SUBJECT: ISSUANCE OF AMENDMENTS - CATAWBA NUCLEAR STATION, UNITS 1 AND 2  
REDUCTION IN REACTOR COOLANT SYSTEM FLOW RATE FOR UNIT 1  
(TAC NOS. M88058 AND M88059)

Amendment No. 113  
License No. NPF-35

Amendment No. 107  
License No. NPF-52

ATTACHMENT TO LICENSE AMENDMENT NO.113

Figure 2.1-1a  
REACTOR CORE SAFETY LIMITS - FOUR LOOPS IN OPERATION  
382,000 gpm

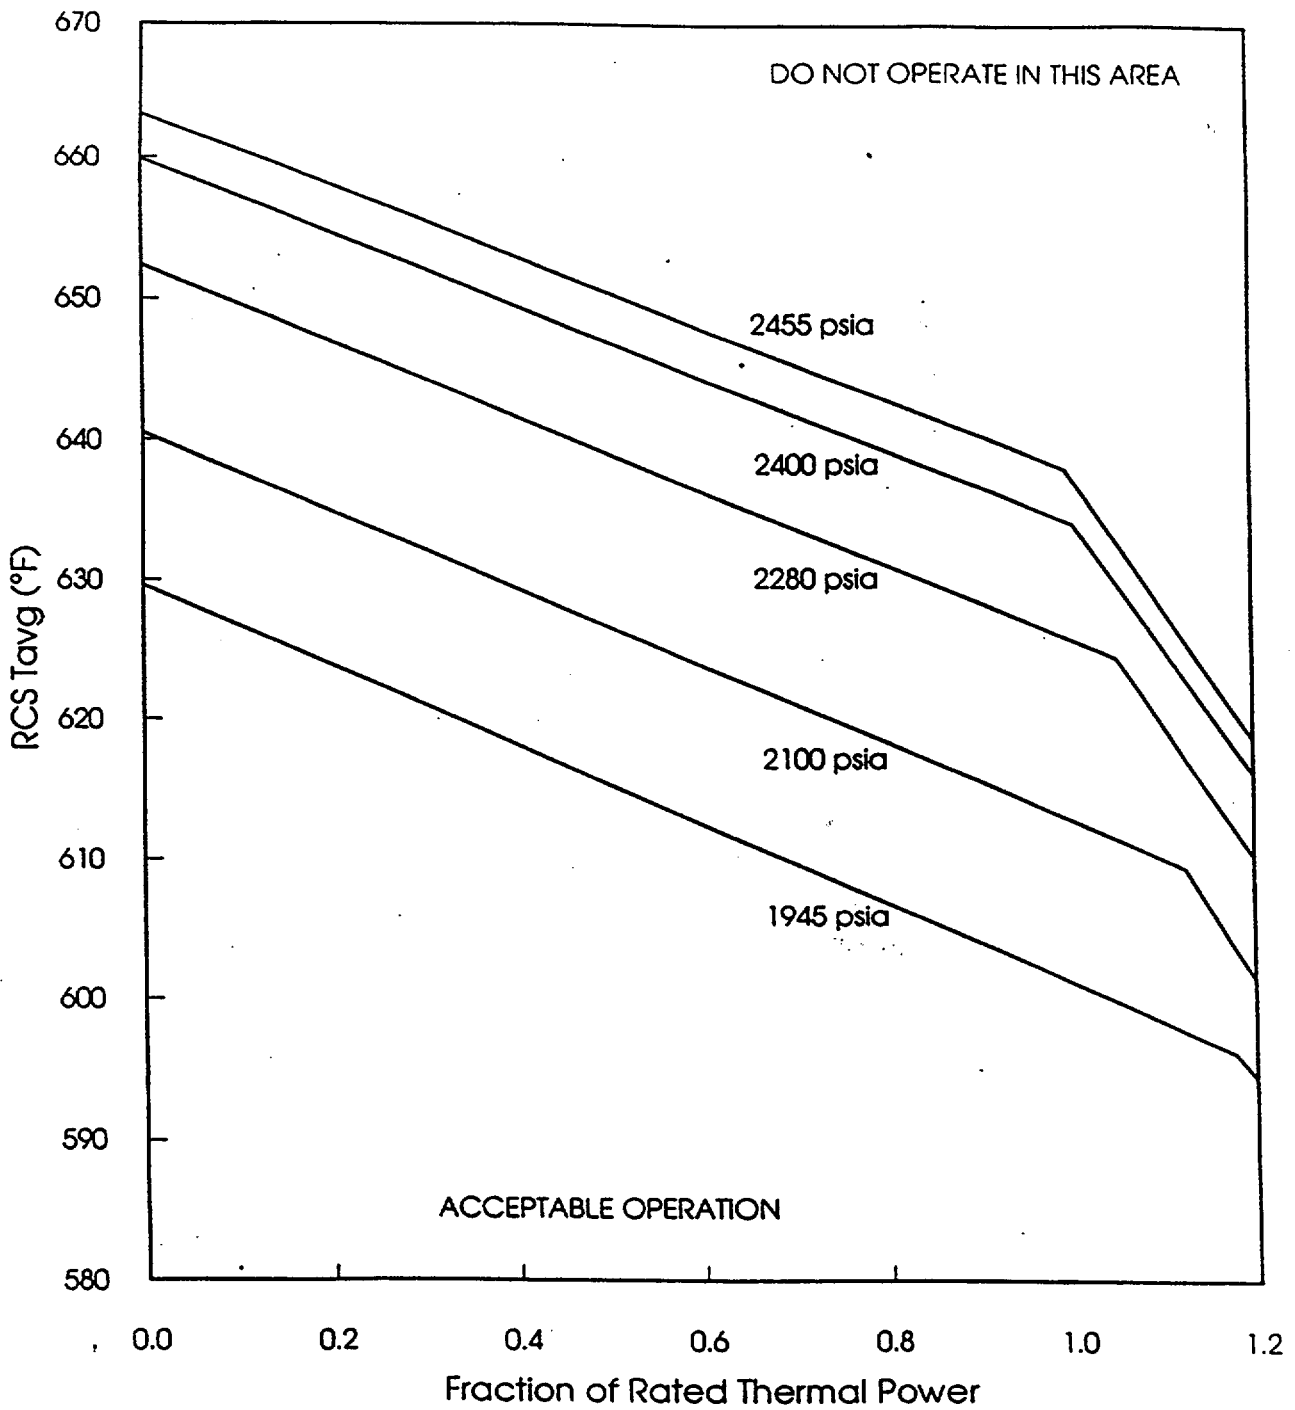
The amendments revise TS Figure 2.1-1, certain TS Table 2.2-1 factors in the equation for the OVERTEMPERATURE  $\Delta T$  and OVERPOWER  $\Delta T$  setpoints, and TS Figure 3.2-1 to reflect a reduction in the required minimum measured reactor coolant system (RCS) flow rate from 385,000 gallons per minute (gpm) to 382,000 gpm for Unit 1. Catawba Unit 2 values are unchanged and, accordingly, certain TS pages are modified to retain the current TS values in effect for Unit 2. The need for the change is attributed to the effects of steam generator tube plugging and to a hot leg temperature streaming phenomenon. The application also proposed to revise the text of TS 2.1.1 and definition for TS Figure 2.1-1. These changes are not related to the changes in RCS flow rate. The staff is continuing to review these proposed changes and, accordingly, they are not dealt with in this amendment.
